# **Pentium® II Processor Specification Update**

Release Date: April 8, 1998

Order Number: 243337-013

The Pentium® II processor may contain design defects or errors known as errata which may cause the product to deviate from published specifications. Current characterized errata are documented in this Specification Update.

Figure 1. UP Dual Ended Termination (DET)

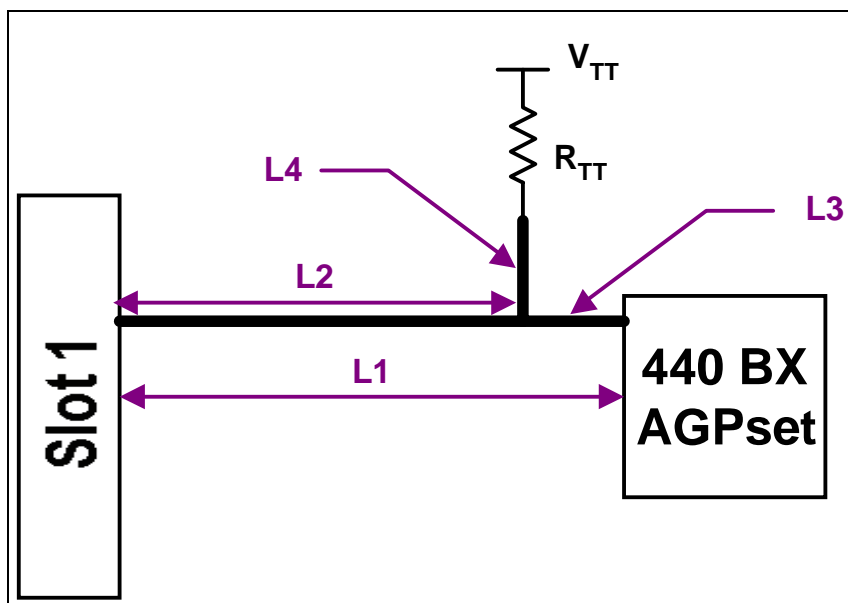
For UP-DET topologies (Figure 1), the trace length L1 must be between 1.5" to 4.5" while using a 56 ohm termination resistor.

Figure 2. DP Dual Ended Termination (DET)

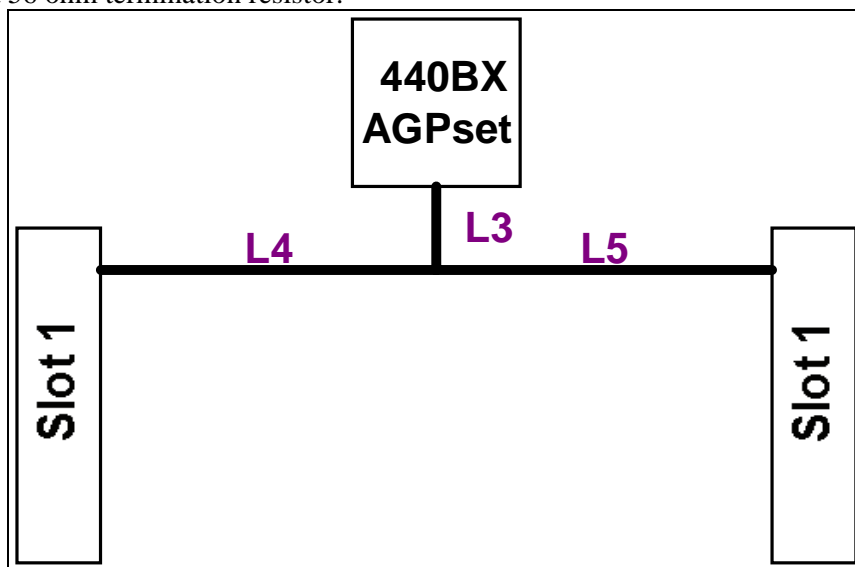
For DP topologies (Figure 2) installed with a processor and a terminator card, on one of the legs, L3+L4 or L3+L5 must be  $\leq 4.5$  and the leg that is  $> 4.5$ " must have the terminator card.

**Figure 23. Processor with an Example Low Profile Heatsink Attached Using Spring Clips**

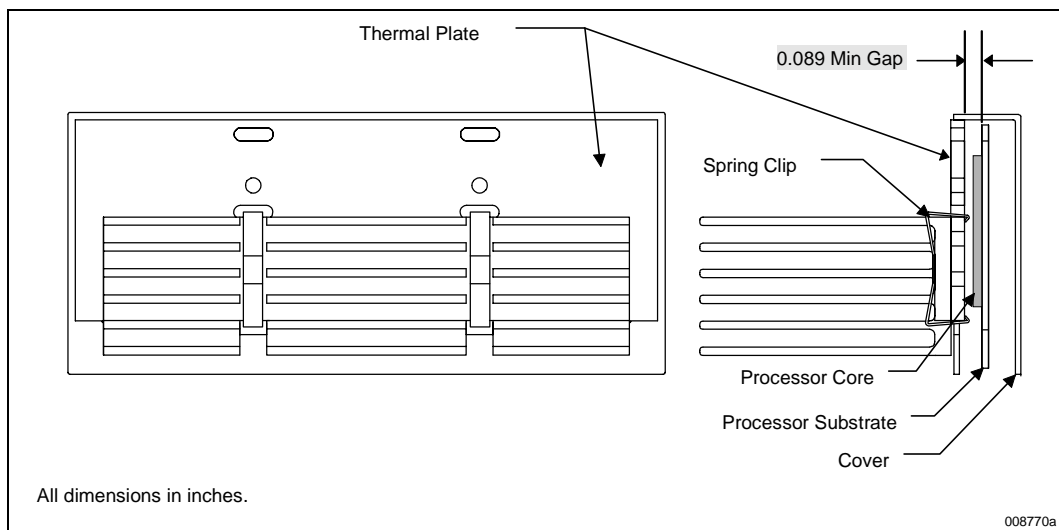
Figure 23 and Figure 24 illustrate example clip designs to support a low profile and a full height heatsink, respectively. The clips attach the heatsink by engaging with the underside of the thermal plate. The clearance of the thermal plate to the internal processor substrate is a minimum **0.089"** (illustrated in Figure 23 and Figure 24). The clips should be designed such that they will engage within this space, and also not damage the substrate upon insertion or removal. Finally, the clips should be able to retain the heatsink onto the thermal plate through a system level mechanical shock and vibration test. The clips should also apply a high enough force to spread the interface material for the spot size selected.

Figure 26. Heatsink Rivscrew\* and Thermal Plate Recommendations and Guidelines

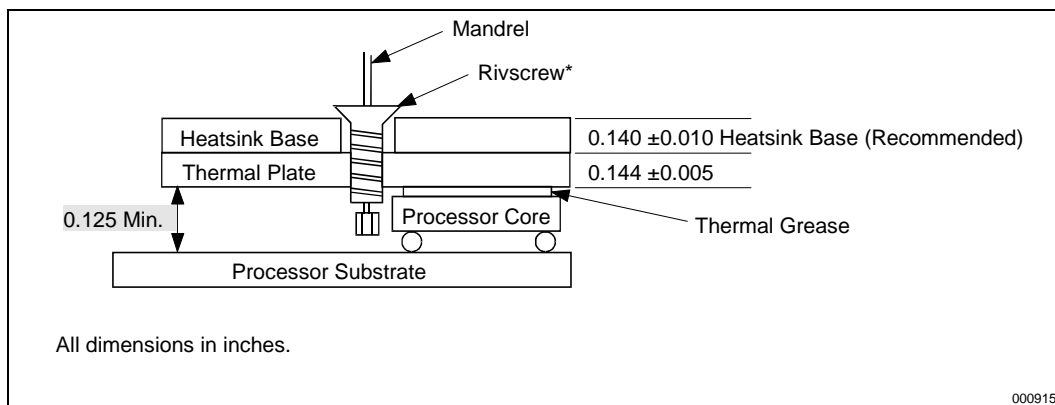
The Rivscrew attach mechanism uses a specialized rivet that is inserted through a hole in the heatsink into the thermal plate. Upon insertion, a threaded fastener is formed that can be removed if necessary. For Rivscrew attachment, the minimum gap between the thermal plate and the processor substrate is **0.125"**. For use of the Advel Rivscrew (part number 1712-3510), the heatsink base thickness must be  $0.140 \pm 0.010"$ . See Figure 25, Figure 26 and Figure 27 for details of heatsink requirements for use with Rivscrews.
